The Development Application for 5-7 Wilga Street provides a reasonable development pattern in terms of the two building model and is of appropriate height generally. However the lack of side and other setbacks is a considerable issue and the implications for 9 Wilga Street are considerable.

## 2. Assessment of the proposal against the NSW Residential Design Flat Code

3. Diagrams showing development pattern and possible streetscape massing

Preferred envelope

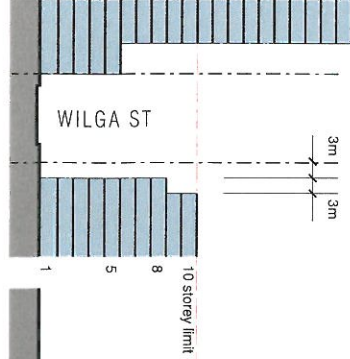
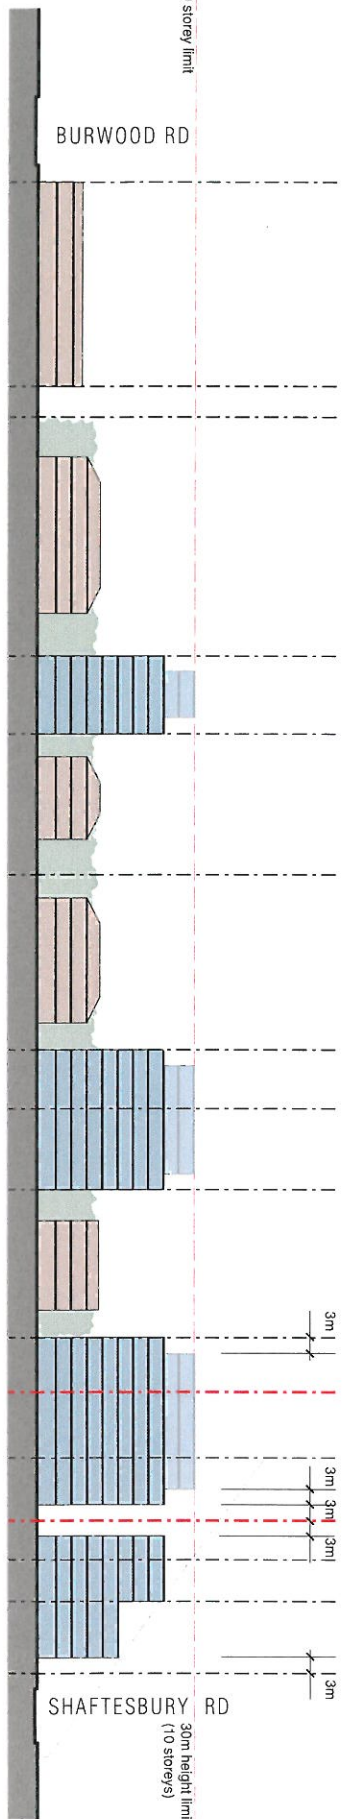
- Provide an opportunity for 9 Wilga Street to share access arrangements and basement car parking and demonstrate that this lot can be developed appropriately or amalgamate the proposal with this lot.
- Redesign the proposal to provide a 3m setback for the 10 storey building to the eastern boundary and a further 3m setback to the upper two floors from the east and south.
- Provide better activation to Wilga Street and a safer, clearer entry.
- Provide visual interest to side walls and roof form
- Redesign the laundries in many units
- Provide balconies to the studio units
- Increase the amount of communal open space to meet the code requirements
- Amend the design to meet the requirements for cross ventilation
- Delete the laundry and full bathroom from the home office
